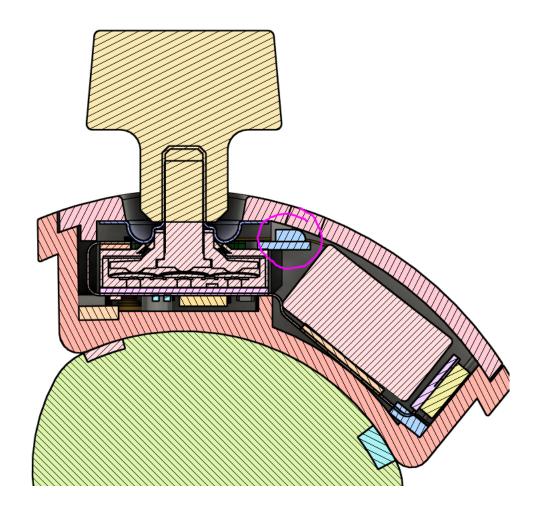
LED is closer to the joystick than Native's design

This is due to the location of the battery. If we were to re-engineer the PCBA to have the LED further to the right we would have to re-certify. In order to deliver products in time for the launch at CES putting the LED in the area circled will be the quickest and easiest route.

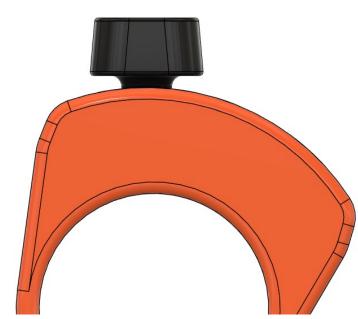
One option we're looking at is to have a frosted surface strip in the top of the plastic case. With the LED in the position shown in the previous CAD this could diffuse the light further away from the joystick with the aperture in the outer silicone being more in the centre of the space between the joystick and the iFIT logo (as per Native's design).

The charging post magnetic strip (shown in grey), at the bottom right, needs to be off-center due to the position of the pogo pins. We could move the pogo pins but that would require more engineering changes on the PCBA to move the contact pads. Our suggestion is to go with the option shown here – when the post is on it's side the user is unlikely to notice the asymmetrical location of the strips.
